PRODUCT / PROCESS CHANGE NOTIFICATION

PCN NO: PCN IN 220323-01

SUBJECT OF CHANGE:

Change of Substrate.

Before	After
<p>Outline Dimension</p> 	<p>Outline Dimension</p>

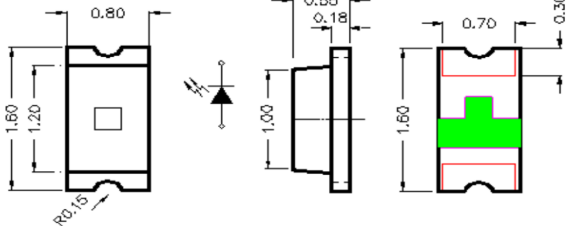
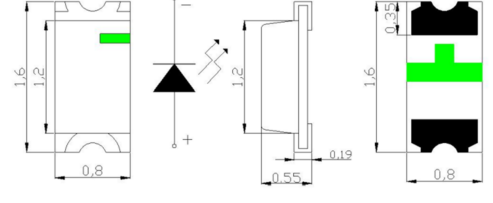
Change the substrate to enhance the product reliability.

Specification: See datasheet (Typical brightness raised from 140 to 320mcd)
